**PERSIMMON HOMES THAMES VALLEY
LAND NORTH OF TODDINGTON LANE,
LITTLEHAMPTON**

**DRAINAGE STRATEGY, WEST OF
WETLANDS
(DISCHARGE OF CONDITIONS REPORT.
CONDITIONS 10, 11, 12 & 13)**

MARCH 2018

McCloy Susdrain Fact sheet

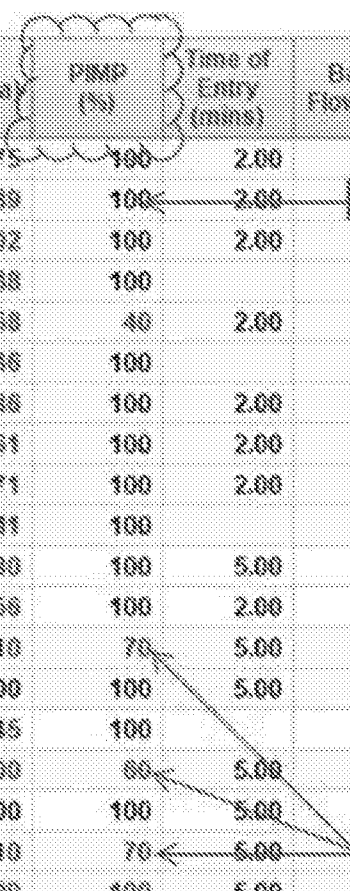
With regards to the Cv criteria I have consulted with the WSCC Drainage Team who have provide two pieces of supporting evidence as follows (see attached):

CIRIA advises that the Microdrainage (and other design software) 'defaults' may not be appropriate. Microdrainage points to Wallingford Vol 1 to determine the calculation criteria, however your reference to Wallingford is not relevant as the catchment is 100% impervious (with no soil factors). Indeed the Wallingford website questions/answers also covers this topic. Whilst I appreciate your summary of your parameters, however it is a **WSCC policy (as LLFA) to use a Cv of 1.0** (100% run-off).

This is a guidance document produced by an independent firm of Consulting Engineers and our Client feels it is not appropriate to use this document as a justification for Cv on this development.

We believe the document, as the title suggests, is an assessment tool for determining storage volumes. At the early stages of most planning applications we produce “Quick Storage Estimates” (QSE) using Windes and we’re 100% confident WSCC have received many of these QSE estimates when reviewing drainage designs. QSE could be viewed as an “assessment tool” to determine high level volumes to ensure sufficient storage space is available within planning applications.

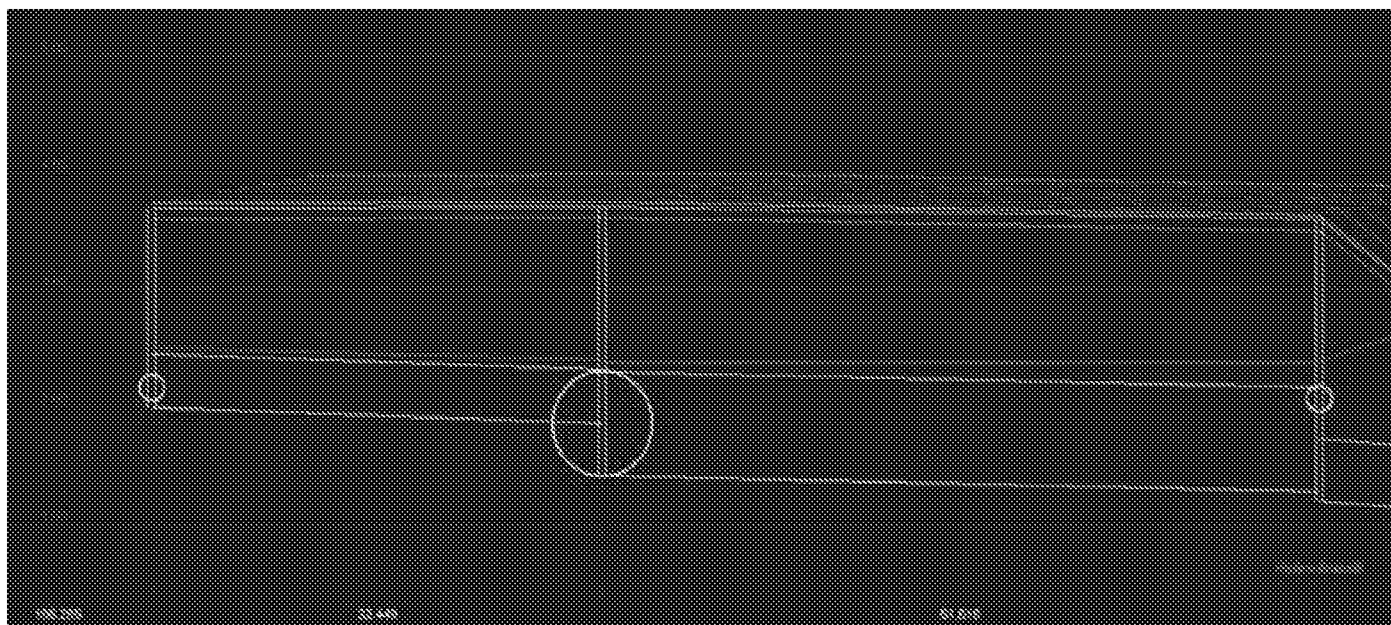
- Item 1 Response - Noted, no further comments.
- Item 2 Response - Noted, no further comments.
- Item 3 Response - Agreed, no further comments.
- Item 4 Response - WSCC has reviewed the Micro-drainage simulation and accept this is a comprehensive model. However, noting the ultimate outfall is to the Black Ditch, it is not clear if this outfall will ever discharge under surcharged conditions. **If so, what bearing will this have on the upstream network and anticipated road extents (public and private)?**

The 1in100yr+CC flood level in the wetlands is 3.23m AOD by the outfall, but this will result in the outfall (@ 1.0m AOD) being surcharged by approximately 2.23m. There will be a flap valve on the final headwall to ensure this floodwater will not back up into the drainage network but in this scenario the drainage network can't push open the flap valve until the water level within the site goes above the flood level in the wetlands. In our opinion the chance of the critical 1in100yr+CC flood level in the wetlands (which is tidal) coinciding with the peak 1in100yr+CC storm event on the site are infinitesimally small.

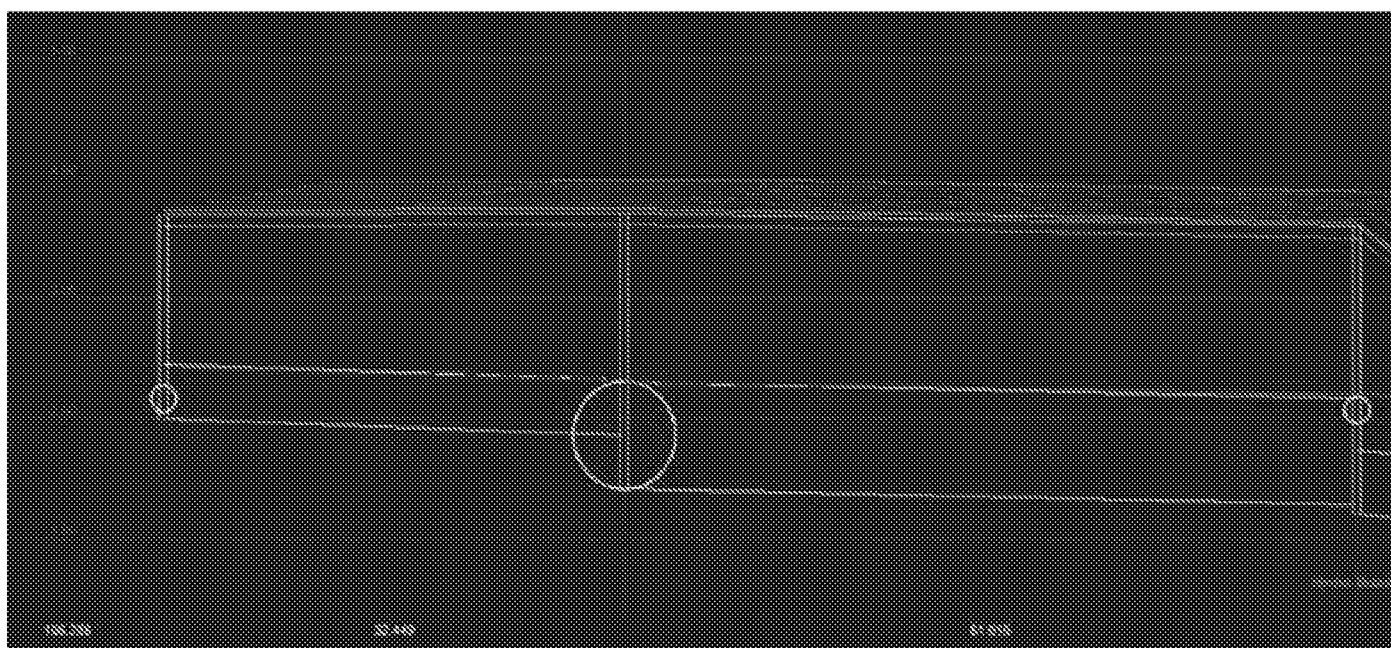
1. Will any flood water continue to flow 'overland' towards an outfall? (It may be prudent to show a basic sketch of the routing through roads/wetlands as you state)

We have however run the simulation with a fully surcharged outfall (@ 3.23m — see image above) and it results in a combined flood volume of 1750m³ escaping from the drainage network. We do not believe it is reasonable keep this flood water on site for this unlikely occurrence and the resulting flood water will flow safely through the road network and eventually into the wetlands.

We've also run the simulations with a 1m surcharged outfall (see image) and it results in a combined flood volume of approximately 500m³ escaping from the network.
